File No: SP 23-03 North Millersburg Conceptual Park Site Plan

Proposal: This site development review is for a new park proposed by the City, more specifically a concept plan for a new 4.4 acre park proposing parking, a walking trail, a playground, a shelter with picnic tables and restrooms, a second shelter with no facilities, landscaping, benches, and some built in recreational features such as bocce ball courts.

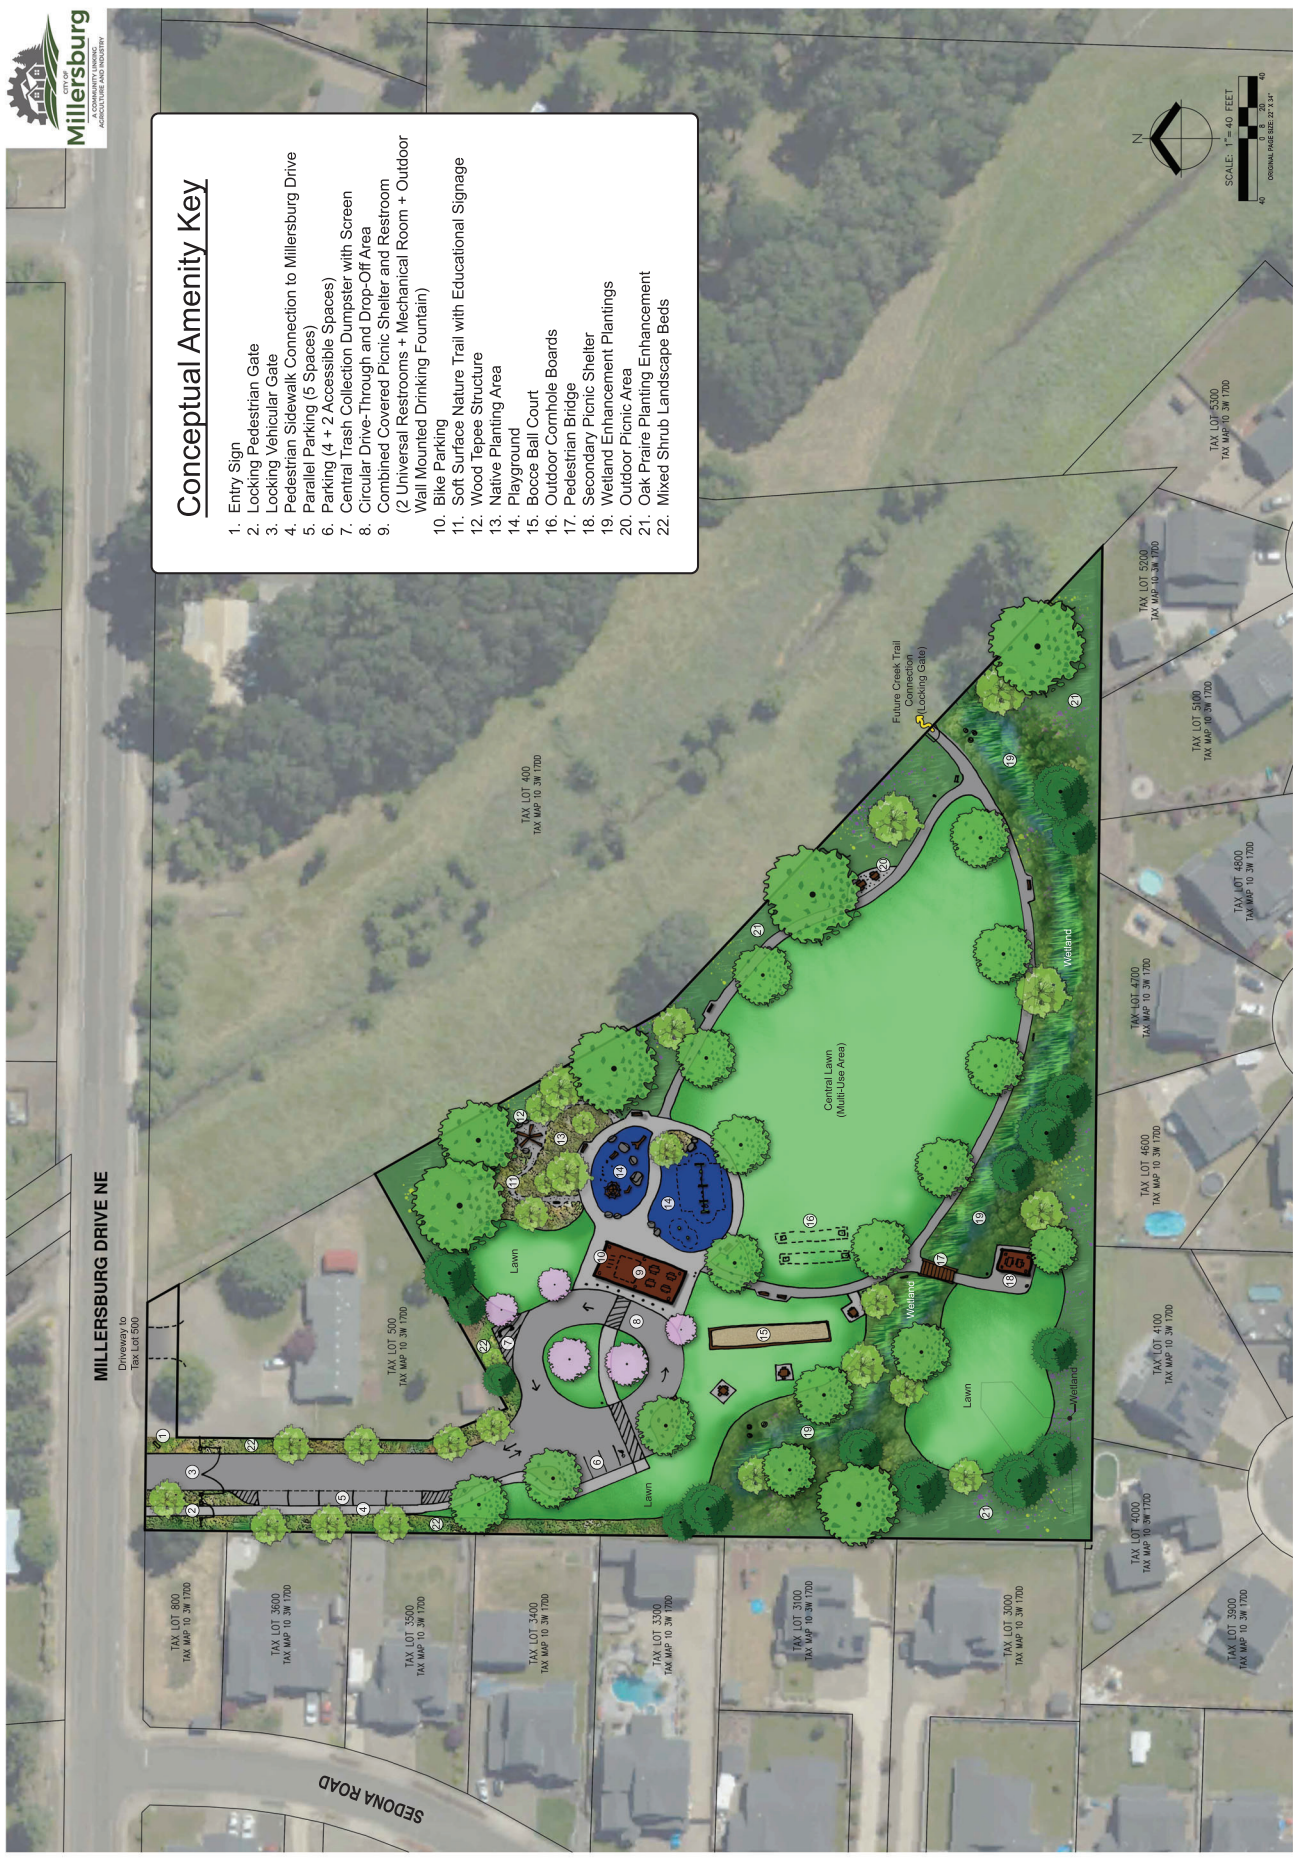
ANALYSIS: The use is permitted in the Residential Low (RL) Zone, specifically Development Code Section 2.03.020(5) lists public parks as a permitted use. It should be noted that a Site Development Review would typically require much more detailed drawings. The City would not normally require a Site Development Review at a concept stage like this; however, the grant that provided the bulk of the funding required that the concept plan culminate in a Land Use approval. Specific structure locations are not shown on this conceptual park design²; however, all planned conceptual structure locations are well outside any structure setback requirements. Structure heights are not known at this time, but will likely be well under the 35 foot height limit. Lastly, while lot coverage cannot be precisely determined at this concept stage, the proposed conceptual plans make it very clear that the lot coverage will be well under the 50% requirements. Only the shelters, the parking lot and perhaps the playground will be impervious. Most of the site will maintain plantings including the large grass area.

ANALYSIS: A park is traditionally located within walking distance of homes. The two uses are traditionally considered highly compatible. Having that said, any park could occasionally result in noise and parking impacts to surrounding homes. The design of the park has taken these potential impacts into consideration and included mitigation in the design to address these possible impacts.

Specifically, on-site parking has been included. This is intended to limit on-street parking on neighboring streets. The project fronts NE Millersburg Drive, but on-street parking is not permitted on NE Millersburg Drive. The closest street where on-street parking would be permitted is NE Sedona Road. The park has been designed with 10 parking spaces. The design carefully considered the potential features and amenities within the park so that there would be nothing within the park that would be likely to attract regional attendance. There is no splash pad, no off-leash dog park, no pool, no highly unique features that would make this a tourist draw of any kind. That was by design, to ensure that the park would not be so popular that it would have many people arrive by car. It is intended to be (as the Parks Master Plan intended) a local park to serve local needs. This should limit the use of cars because most people who use the park should be within walking distance of the park.

Regarding noise, the amenities within the park were included with the intent of assuring that no overly noisy use is included. There are no sports fields, no basketball courts, no stage or amphitheater, no bandstand, no other uses that would traditionally be noisy, with the exception of the playground, and the location should mitigate that effect. The playground area has been located specifically to assure that it is as far as possible from any neighbors. Plantings have been located to buffer noise from the existing homes (once they are mature). Additionally, the Parks Commission has specified that the playground is *not* one with built in musical instruments (no music garden). With these

ANALYSIS: The site will require all new utility connections, as nothing has ever been developed on the site previously (except one out-building that only had power). There is a 12-inch ductile iron waterline, and a 12-inch sewer line located in NE Millersburg Drive. A water meter will need to be added. A drainage study was not yet performed. A condition of approval has been added to require a drainage study with the building permits. An erosion control plan will also be required.

ANALYSIS: Parking is reviewed below in the 'standards' section of the staff report. The project fully complies with the Code requirements for parking. Access is provided from NE Millersburg Drive. Pedestrian access has been included in the parks design connecting the park site to NE Millersburg Drive sidewalks. Additionally, the park has been planned for a future pedestrian connection to a trail that is shown in the Transportation System Plan and the Parks Master Plan that will span the eastern edge of the park site, someday.³ Bike parking is planned.

ANALYSIS: As noted above, the proposed park use is fully compatible with residential uses. Mitigation has been added, however, to address concerns expressed during public outreach. As noted above these will include the location of potentially noisy uses and plantings around the edge of the park site where the site borders homes. These will also act to visually screen the park site from the neighboring homes, very similar to the homes that have backed to the Millersburg Park site for several years. None the less, a condition of approval has been added to specify that some screening must be included.

ANALYSIS: Table 14 lists uses and spaces required for those uses. Parks are not specifically listed. Pursuant to Section 3.03.050(2) the Planning Director can interpret uses that are not specifically listed. Ten spaces is appropriate given the kinds of amenities planned for the park.

In the final design all parking stalls must meet size requirements, and the drive aisle is 24 feet wide.

- Stormwater detention and water quality facilities shall be designed as required to meet City standards. Stormwater calculations shall be submitted to the City Engineer for review and approval. Maintenance of detention basin and water quality facilities shall be the responsibility of the City.

- Prior to issuance of building permits, the City shall approve a landscape plan showing the proposed landscaping for the site which must include visual screening of surrounding houses. Not every home must be screened, and the screening need not be effective at the time of planting. The plans must show that at least 60% of the surrounding homes are screened at 15 year maturity. Said plan shall be fully consistent with the requirements of 3.09.030(1)b or c.
